Technical Service Bulletin

SUBJECT:		No: TSB-16-54-005	
UNABLE TO RE-REGISTER IMMOBILIZER ID AFTER REPLACING ETACS ECU		DATE: October, 2016	
		MODEL: 2014-16 Outlander	
CIRCULATE TO:	<input type="checkbox"/> GENERAL MANAGER	<input checked="" type="checkbox"/> PARTS MANAGER	<input checked="" type="checkbox"/> TECHNICIAN
<input checked="" type="checkbox"/> SERVICE ADVISOR	<input checked="" type="checkbox"/> SERVICE MANAGER	<input checked="" type="checkbox"/> WARRANTY PROCESSOR	<input type="checkbox"/> SALES MANAGER

A. REGISTRATION FLOW CHART

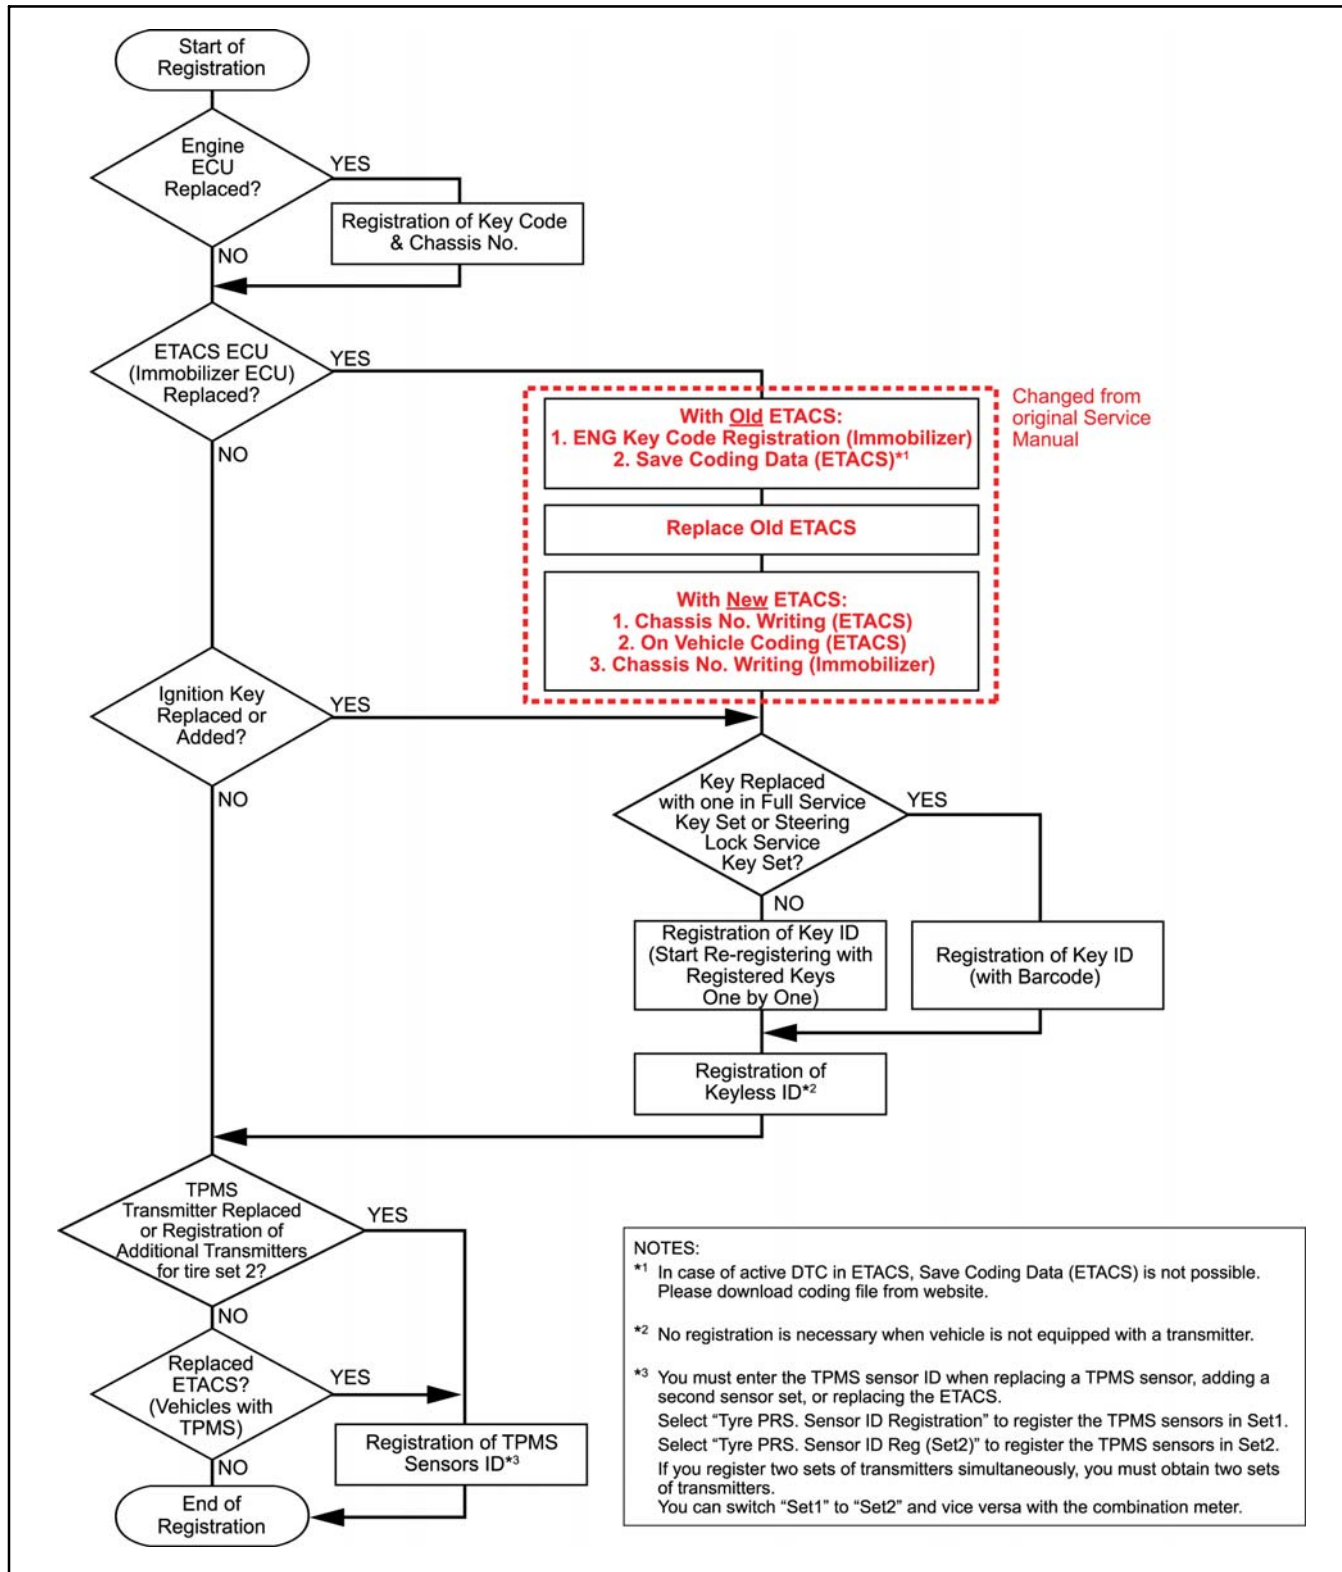
Please note changes from original Service Manual instructions in **red**.
